**December 16, 2017**

07725 Version 5

**Safety Recall: Second Row (Both Outer) Seats Walk-in Function**

Supersedes 16-108, Safety Recall: Second Row (Both Outer) Seats, dated July 29, 2017, to revise the information highlighted in **yellow**

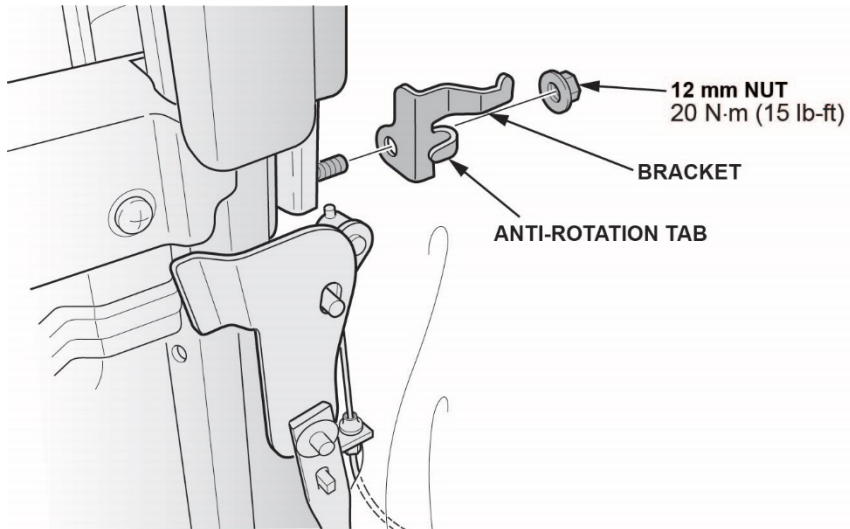
4. Remove the 12 mm nut located on the back of the seat rail (left side second row outer slide rail shown, others are similar).

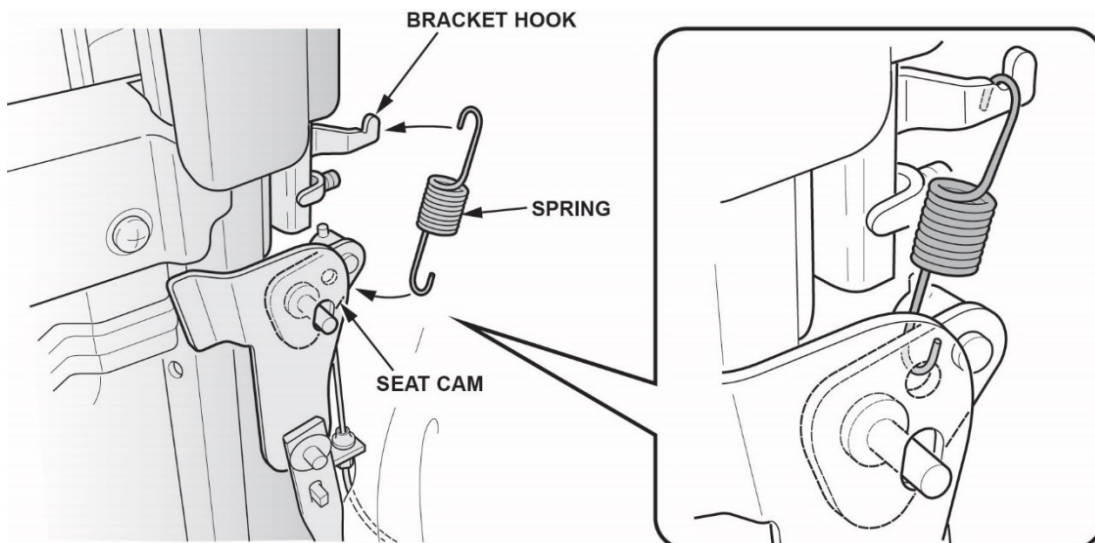
5. Install a bracket from the kit over the stud shown. Make sure the hook part of the bracket faces the back of the seat and the anti-rotation tab contacts the seat rail.

6. Reinstall the original 12 mm nut using a 3/8 in. flexible head torque wrench. Torque the nut to **20 N·m (15 lb-ft)**.

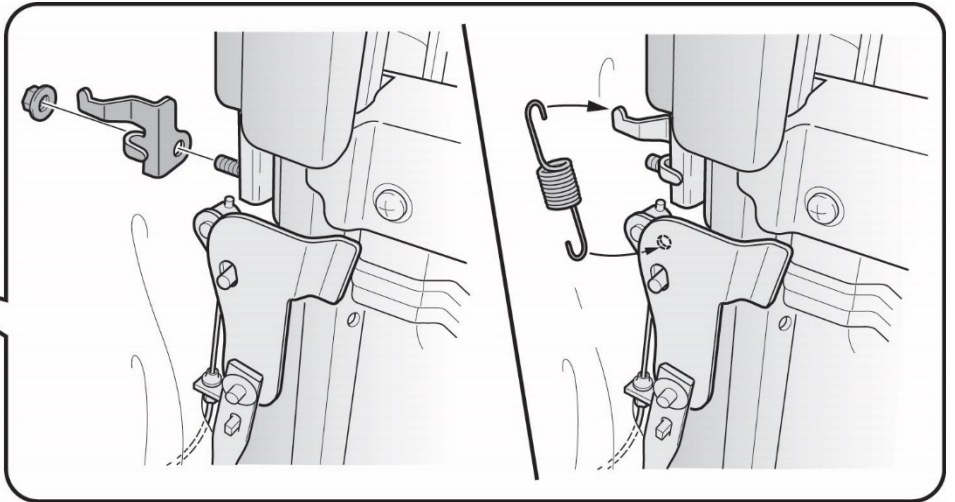
7. Install the spring from the kit through the back of the seat cam as shown.

8. Install the other end of the spring onto the bracket hook as shown.

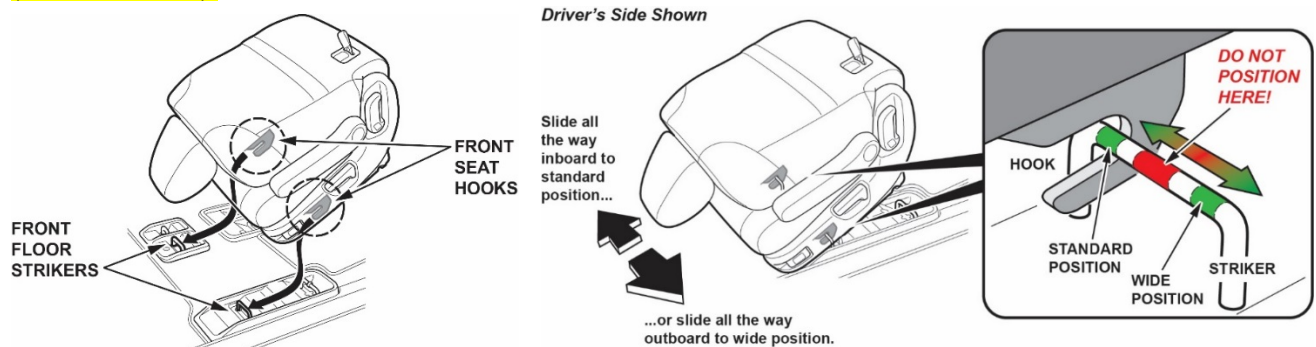
10. Insert the front seat hooks into the front floor strikers and slide the seat into either the Standard or Wide position until it stops (identified in green).

**NOTE:** Do not position the seat hooks in the middle of the striker. The seat will not lock into position (identified in red).

Driver's Side Shown

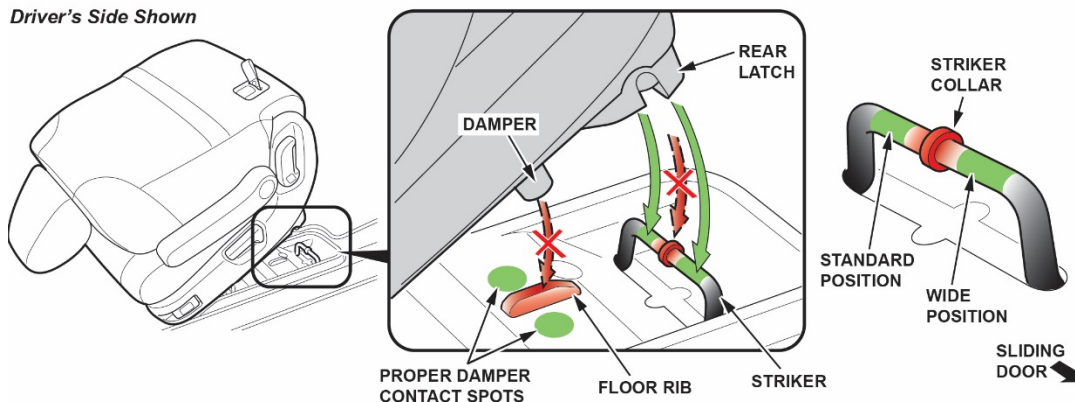
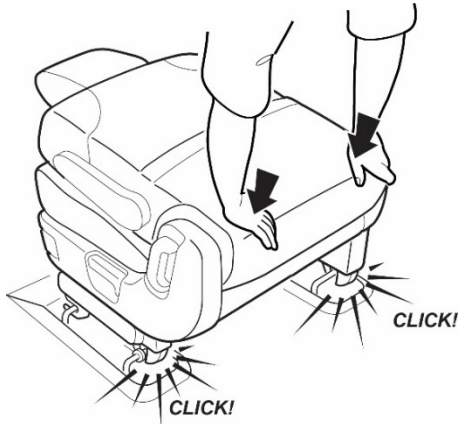
11. Lower the rear part of the seat. There is both a rib on the striker cover and a collar on the rear metal striker. Check that the rear latch and damper are on one side of the rib and collar, which is identified in green.

- The rib and collar separate the standard and wide seat positions.
- Do not latch the seat in the middle (identified in red), the damper and rear latch will rest on the rib and collar, and will not lock.

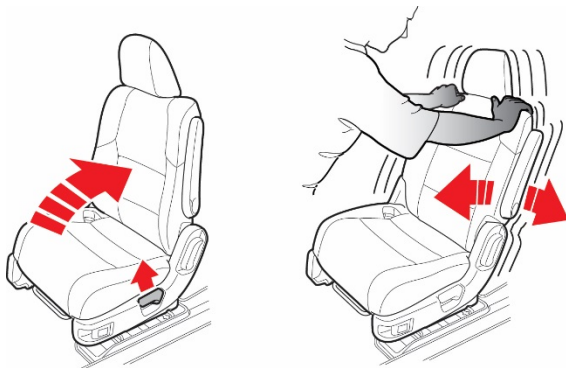
12. Once in position, push down the rear of the seat to set both rear latches. The latches click as they engage the floor strikers.
